Subject : 202112-16010 EC - (QHR600189) - IR [DELEGATE APPROVAL]

**Heritage Protection of State Heritage-Listed Mowbray Park, East Brisbane.**

Proposed demolition of former East Brisbane  
Bowls Club building

Heritage Impact Assessment Report

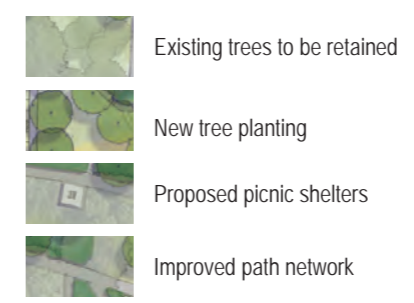
- The QHR entry recognises the high "importance of the park as a focus of community recreation". The History element of the QHR entry states "the whole park reserve is significant."
- The current exemption certificate application addresses that the buildings themselves are not of particular heritage significance however the application does not signal the future use of the area of the bowling green or the provision of new interior recreation space to replace the amenity lost by demolition of the bowls club.
- Readily available online published 'draft vision' shows a rendering of a carpark replacing the bowling green and text notes the 'carpark

shifted to bowls green to allow more active riverfront green space.” (Source image appended)

- This replacement of bowls green with carpark indicates that the change is of more than minimal detrimental impact to the State heritage place.

**Figure 1:** Mowbray Park Concept plan – subject to change through detailed design phase

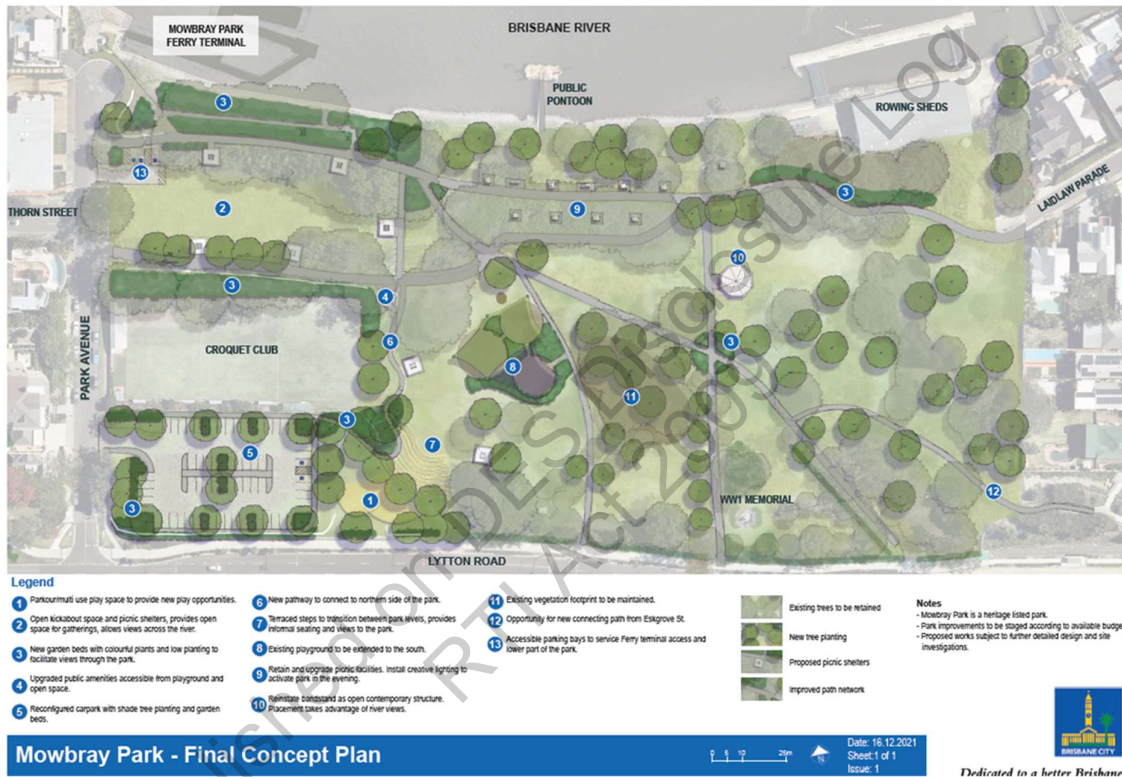
- 1.) *provide a satisfactory Information Request response to demonstrate that the development will result in at most minimal detrimental impact on the place's cultural heritage significance. The masterplan of the Mowbray park proposal, **addressing the continuity of the recreational use of the site** would need to be supplied as part of the application / information request response. BCC would need to show how an equivalent and similar type of structured recreational activity is provided at the place—and the HIS needs to address Criteria G&H of the Statement of significance of the QHR entry.*

The proposal as submitted is for a small portion of the overall work intended for Mowbray Park. The decision to lodge a single initial HEC to assess the removal of the Bowls club building stems from a desire to remove the building rather than spend unnecessary money on its upkeep when the built form is not reflective of the desired future use of the park and the building is no longer intended to be tenanted past March 2022

Whilst Council respects DES' observation that the application may appear to be piecemeal, the work represents part of a broader concept intended for the entire park which is shown in the attached plan. The concept plan has been formulated through assessment of site opportunities and constraints, and consultation with the public, but not yet been developed to a point that it can be represented by design plans sufficient in detail to be suitable for an application. Removal of the Bowls club building is proposed as a first stage of works with subsequent upgrades consistent with the attached plan. There is a desire to remove the building to allow for appropriate detailed design investigations to be undertaken and prepare the site for future works.

As shown on the concept plan and notes – the future works will be assessable under the gambit of a development application (DA) to DES. The works may also constitute a material change of use application to Brisbane City Council’s Development Services, however this is subject to final scope and further planning investigations. It is premature to prepare the development application at this time, as outstanding site investigations are yet to take place.
